PLANNING ISSUE	DWG		REV C: UPDATED EXTERNAL LIGHTING POSITIONS	NOV 21	
	DWG		REV B: UPDATED FOLLOWING SITE VISIT WITH PLANNING OFFICER AND CONSERVATION OFFICER FROM MMC	JUNE 21	
	DWG		REV A: NOTE ADDED	MAY 21	
	DWG		DRAWN	APRIL 21	
	DRAWN		REVISION	DATE	
	PROJECT				
	MEDLOCK VICTORIA MILL MILES PLATTING				
	TITLE				
	NORTH EAST ELEVATION RECORD PHOTOGRAPHS AND REPAIRS REQUIRED				
	SCALE				
1:200 @ A1					
JOB No		DRAWING No		REV	
MED02		AP201		C	
 ALLISON PIKE ARCHITECTS & DESIGNERS 7 Buxton Road West, Disley, Stockport, Cheshire, SK12 2AE. Website: www.allisonpike.com Telephone: 01663 763000 Facsimile: 01663 766772 Email: studio@allisonpike.com © Allison Pike Partnership Limited.

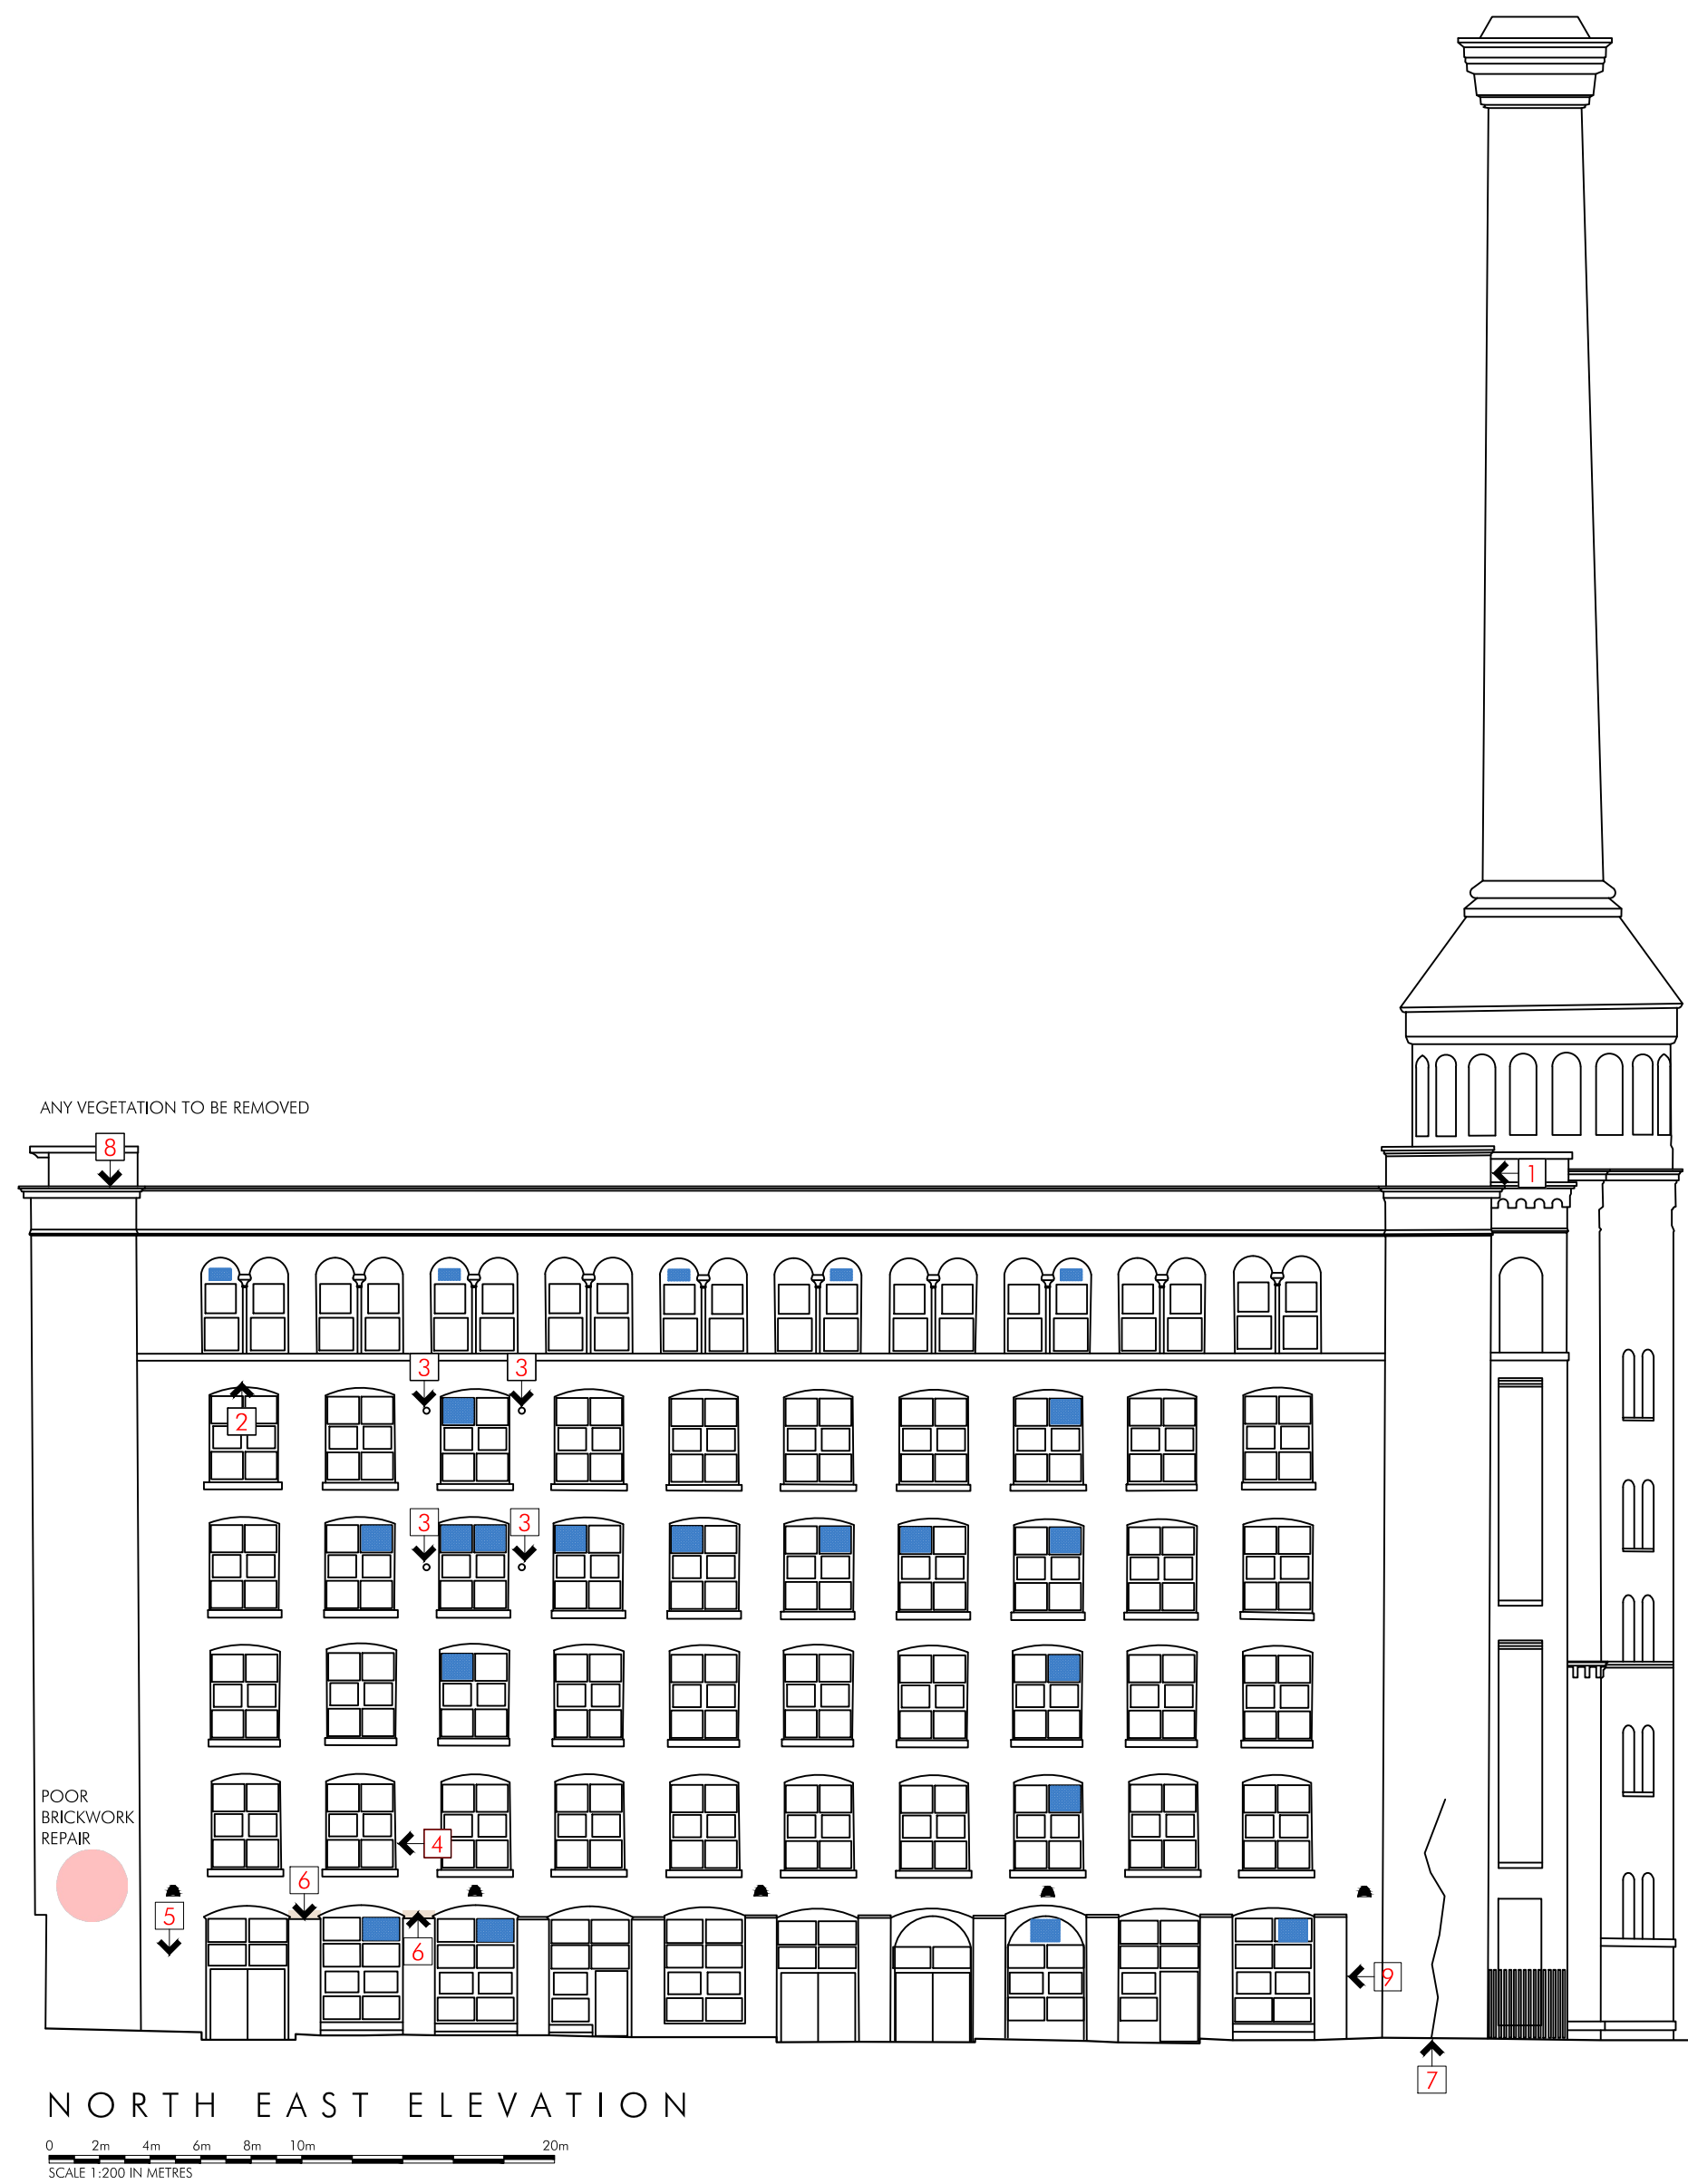
1. Damaged edge to string course. Stone repair required.

2. Damaged pointing above window head and widow cill to window above. Repointing required with mortar to match existing.

7. Cracking in brickwork. Assess condition of brickwork and mortar. Stabilise if necessary, replace cracked bricks repoint with mortar to match existing.

8. Damaged cornice. Stone repair required.

9. Crack between pier and main wall to be repaired with mortar to match existing.

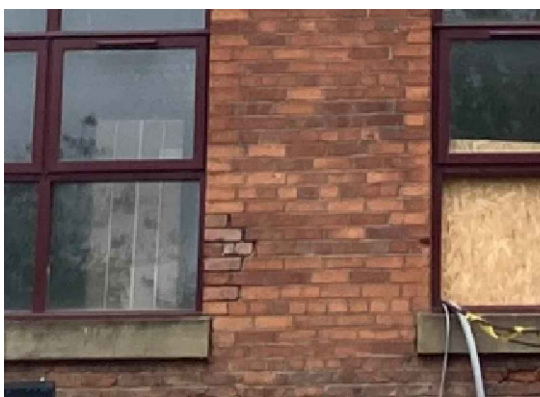
3. Existing metal stabilisation plates to be left in place.

4. Loose brickwork to window reveal. Loose bricks to be rebbed in mortar to match existing.

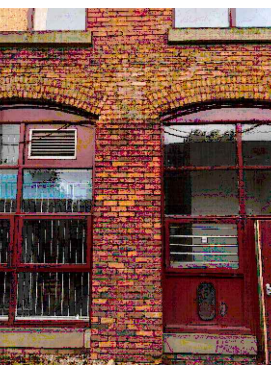
5. Staining to brickwork. Brickwork to be cleaned with a steam cleaner. Brickwork to be repointed if necessary. Mortar to match existing.

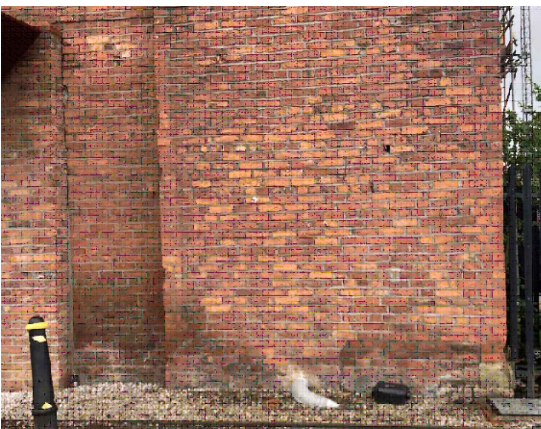
6. Cant bricks to top of brick piers missing. New cant bricks to match the existing cant bricks to the top of adjacent piers, are to be installed.
